SUBJECT: Response to NRC Request for Additional Information Pertaining to  
Request for Alternative ANO2-R&R-002, Rev. 1

Arkansas Nuclear One, Unit 2  
Docket No. 50-368  
License No. NPF-6

**REQUEST FOR ADDITIONAL INFORMATION REGARDING  
REQUEST FOR ALTERNATIVE ANO2-R&R-002, Rev. 1**

CALCULATION CN-CI-02-6, REV 0, "Analysis of ANO-2 Pressurizer Heater Sleeve MNSA-2 Designs" dated March 21, 2002<sup>1</sup>

Appendix B2: Grafoil Seal Transfer Coefficient

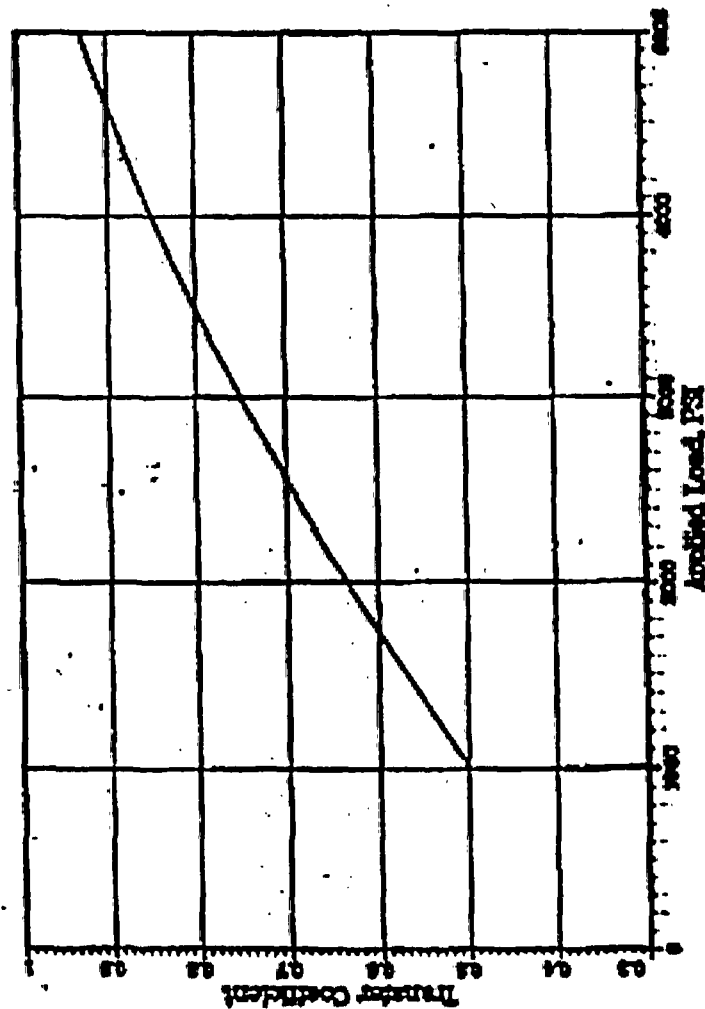
- 1.0 Section 3.1.4, "Sealing Pressure," (page 9) states that the radial pressure against the pressurizer (PZR) bore and the heater sleeve is at least 80% of the axial pressure. Please indicate where this determination is demonstrated in Reference 6 of the calculation.

*The Grafoil Literature Sheet, documented in Union Carbide Corporation's Engineering Design Manual, Vol. 1 (Reference 6 of CN-CI-02-6) and provided in Attachment 1, shows the increase in radial load transfer with applied axial load. As evidenced from the graph, a transfer coefficient of 80% results in an applied load of 3,500 psi.*
